Travaux en électricité - Mise à niveau du système d'alarme d'incendie

Modification 2 : Prolongation de la date de clôture de la période de soumission ET publication de réponses aux questions reçues

Electrical Work - Fire Alarm System Update

Amendment 2 : Extension of bid submission deadline AND publication of answers to questions received

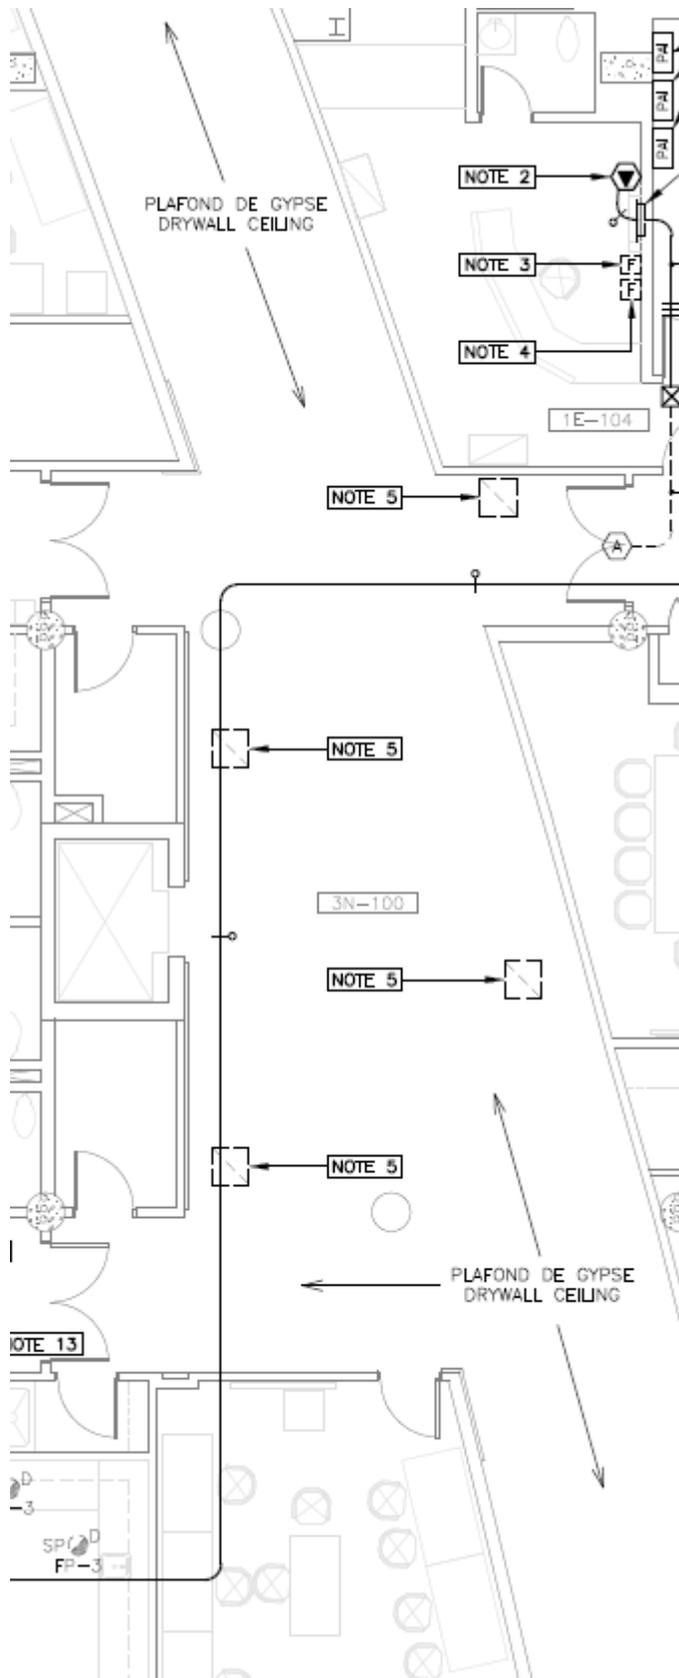
Q2 : *Précisions sur le devis*

Le code électrique du Québec 2018 (C22.10-18) avait déjà interdit l'installation des conduits directement sur le platelage. Voici des extraits provenant de l'explicatif sur les principaux changements :

Distinction entre où il y a des plafonds en gypse (car il peut nécessiter un ragréage et des trappes d'accès à la suite du passage des conduits) et où il y a du platelage (car à ces endroits, il pourrait avoir à installer des profilés pour distancer les conduits).

Pour ce qui est du platelage, avec des plans de structure/architecture, il serait surement possible d'avoir l'information. Normalement, rendu sur le chantier, l'entrepreneur s'accroche aux poutres ajourées comme dans la 2^e image ou ajoute les profilés nécessaires.

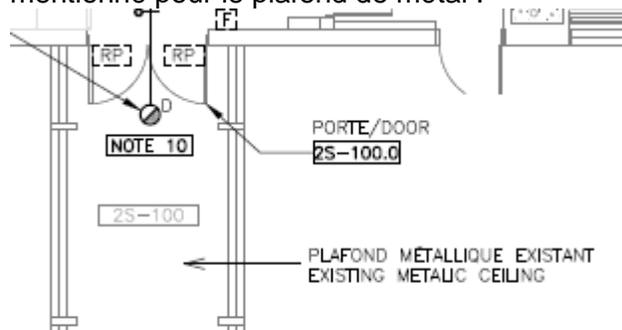
La note 11 du plan E602, la note 9 du plan E604 et la note 6 du plan E606 mentionnent que de façon générale les plafonds sont en tuile et que les exceptions sont indiquées. Dans E602 on voit :

Dans ce corridor, c'est du gypse et qu'une fois les portes traversées, c'est de la tuile. Il est aussi mentionné pour le plafond de métal :

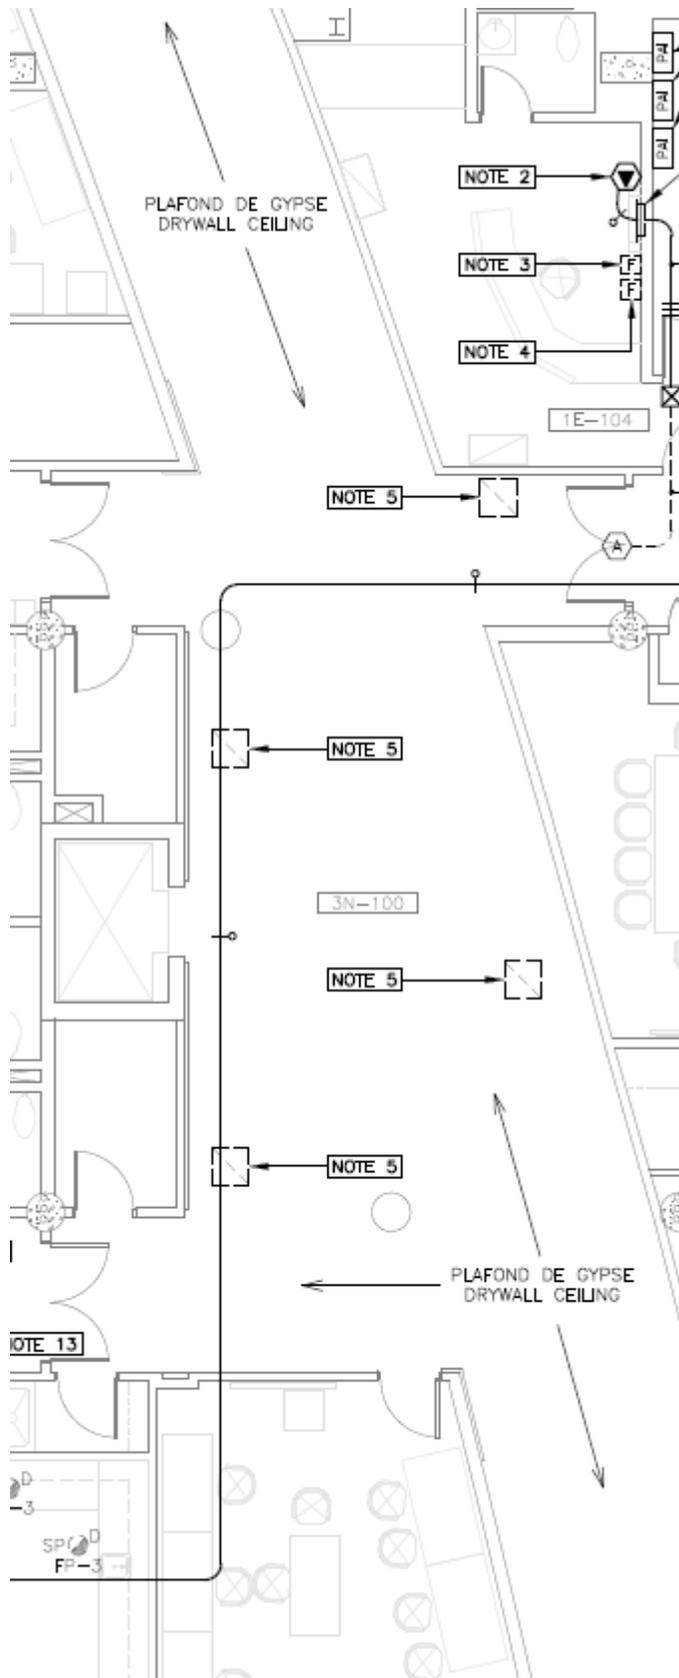
Q2 : Precisions on the specifications

The 2018 Quebec Electrical Code (C22.10-18) had already prohibited the installation of conduit directly on the decking. Here are excerpts from the explanatory text on the main changes:

Distinction between where there are gypsum ceilings (as it may require patching and access hatches as a result of the passage of the conduits) and where there is decking (as in these areas it may have to install channels to space out the conduits).

As for the decking, with structural/architectural plans, it would surely be possible to have the information. Normally, when the contractor is on site, he hangs on the openwork beams as in the 2nd picture or adds the necessary profiles.

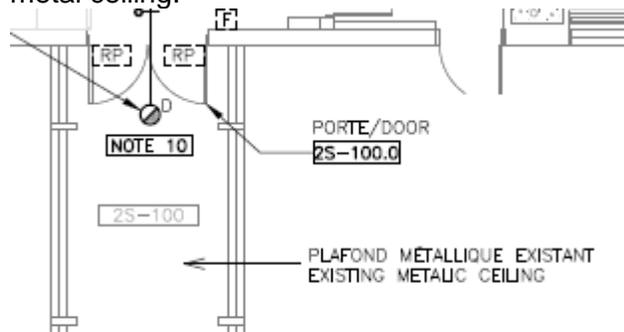
Note 11 of plan E602, note 9 of plan E604 and note 6 of plan E606 state that generally ceilings are tile and exceptions are indicated. In E602 we see:

In this corridor it is gypsum and that once you go through the doors it is tile. It also says for the metal ceiling:
